Number	A.1.
Section	General Information
Sheet	1 (of 1)
Date	January, 1960

PRELIMINARY INFORMATION

(Mark 2 Models)

SERVICE BULLETIN NO. 187

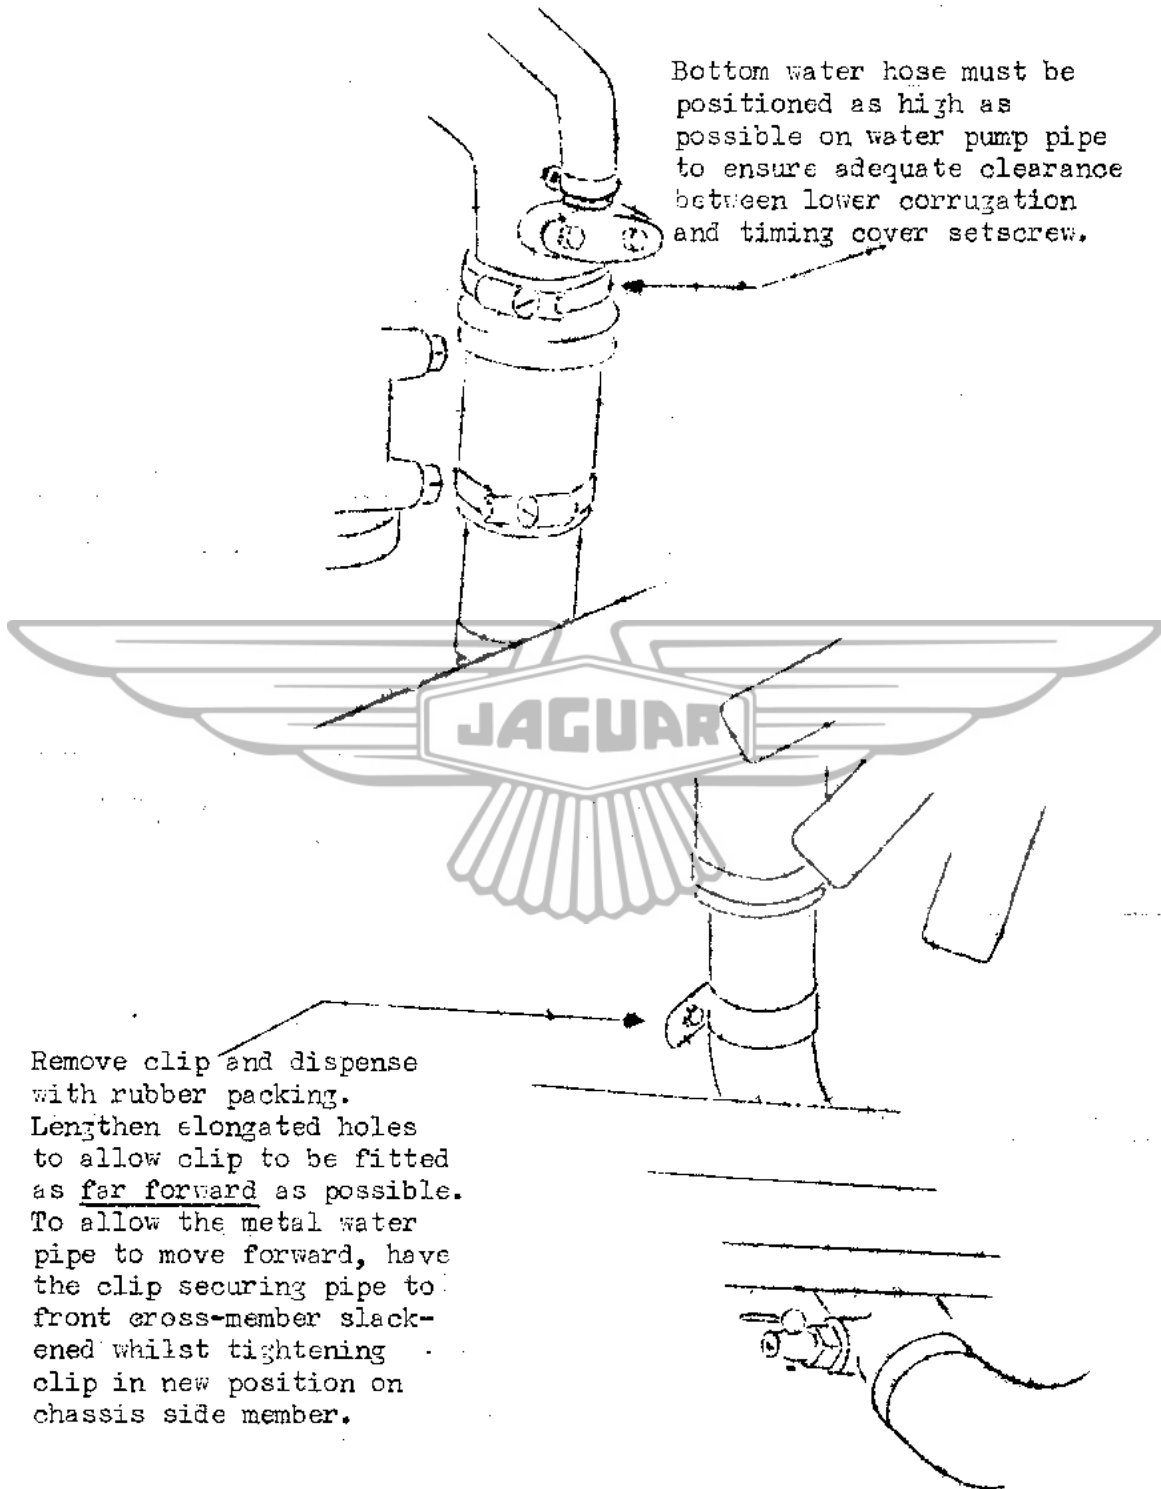
In some instances, on left hand drive cars prior to the above chassis numbers, the water hose between the water pump and the metal pipe may be positioned too close to the timing cover with consequent chafing between the hose and timing cover setscrews.

Distributors and dealers are, therefore, requested to examine all XK.150 cars prior to the above chassis numbers, which come into their premises, for adequate clearance between the hose and timing cover setscrews. If insufficient clearance exists the following rectification procedure should be carried out and if chafing of the hose has occurred a new hose (Part number C.12924) must be fitted.

Wiring Instructions.

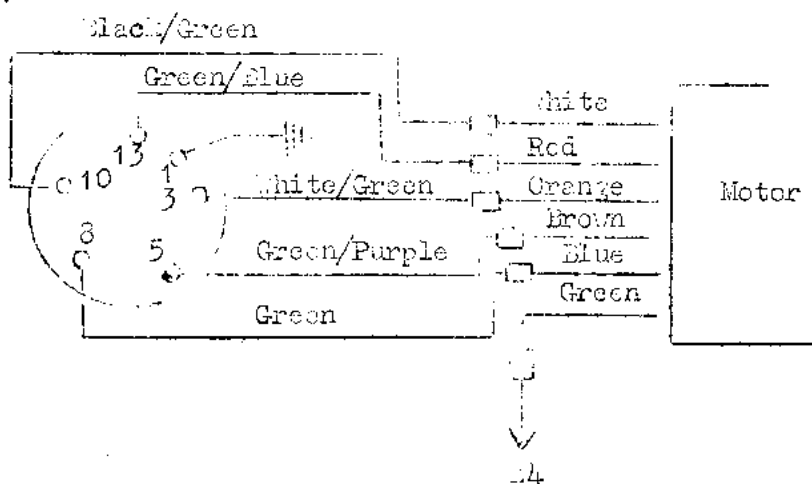
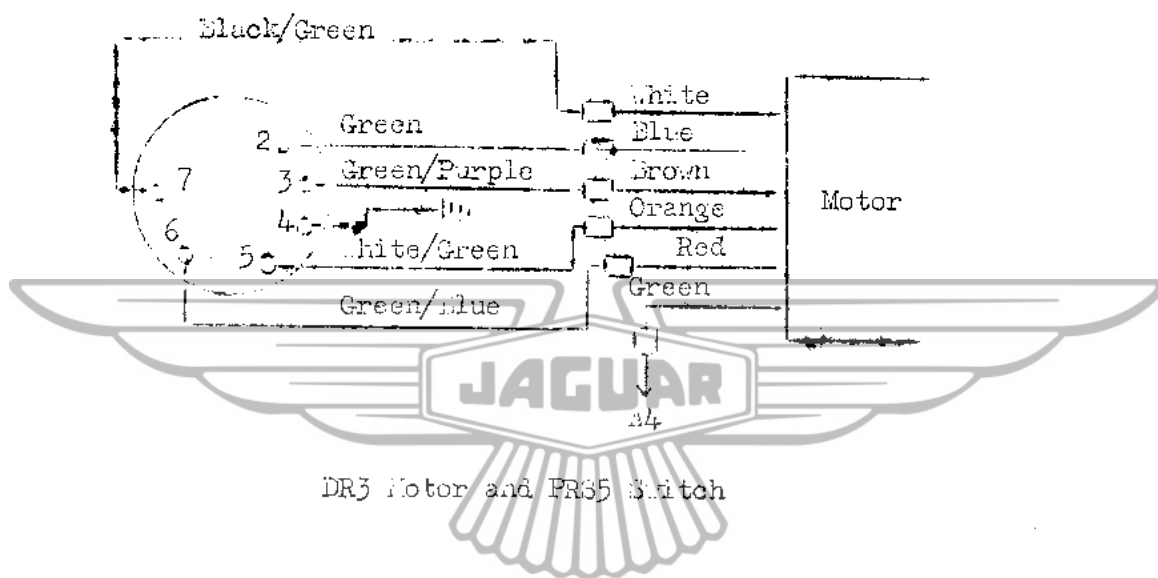
- 1) Cut off the original five connectors from the wiper motor harness, and solder on the five "bullet" connectors.
- 2) Using rubber snap connectors, connect the leads from the DR3 motor to the harness, as illustrated below. (it will be seen from the two circuits that two methods of wiring are involved dependent on whether the vehicle is equipped with a Model PRS5 or PRS7 panel switch.)

Check 1.

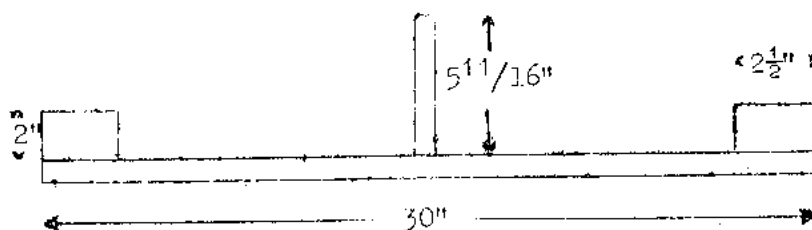
Check the distance from the bottom of the front flange of the front propeller shaft to the bottom faces of the longitudinal chassis side members. This distance should be $3.11/16" \pm 1/16"$ ($93.5 \text{ mm} \pm 1.5 \text{ mm}$). A simple checking jig can be made for checking this distance as shown in the following sketch.

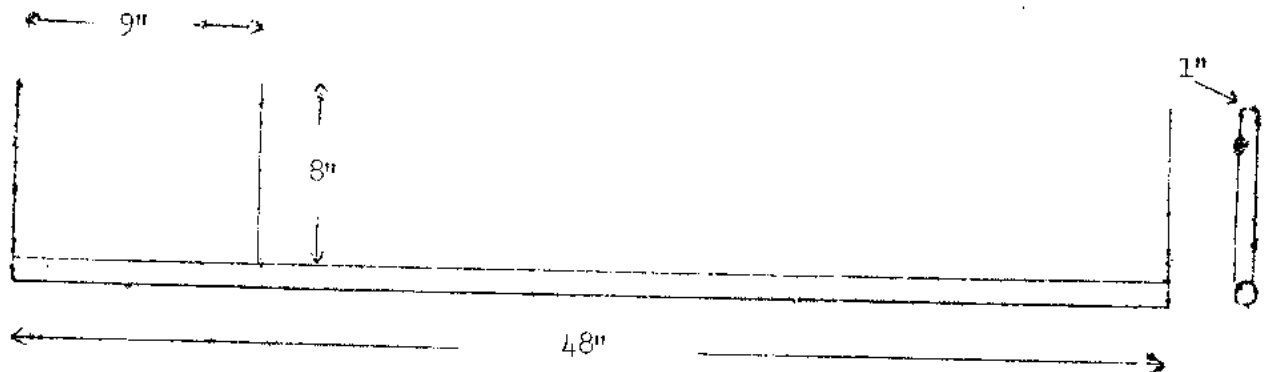
The most convenient way to do this is to make up a simple jig as shown in the following sketch. The jig consists of 3 pieces of flat bar 8" x 1" x 3/16" (20.5 cm x 2.5 cm x 4.75 mm) which are welded exactly in line on to a piece of tube of 1 1/8" (28.5 mm) outer diameter at the distances shown in the sketch. The jig is then held against the front and rear propeller shafts, with the two bars vertical, when any malalignment will be evident.
